## **URGENT - Field Safety Notification Medical Device Correction**

### **Philips HeartStart MRx Monitor/Defibrillator on exceptionally rare occasions may exhibit abnormal behavior when operating using a single battery as the sole source of power.**

**Figure C: AC Module Removal**

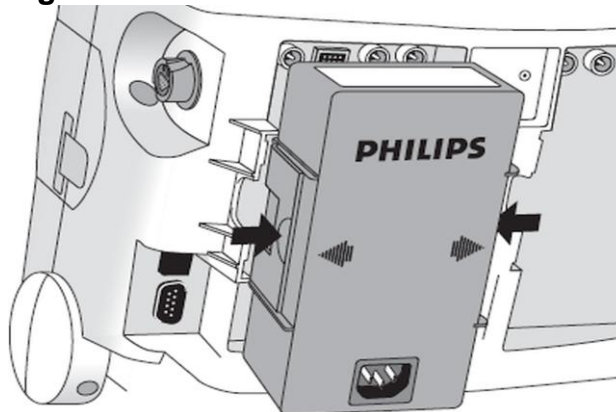
There are two ways to prevent this power switching. The user can either:

- a. Remove the AC module from the MRx, rather than unplugging the cord from AC mains (see Figure C).
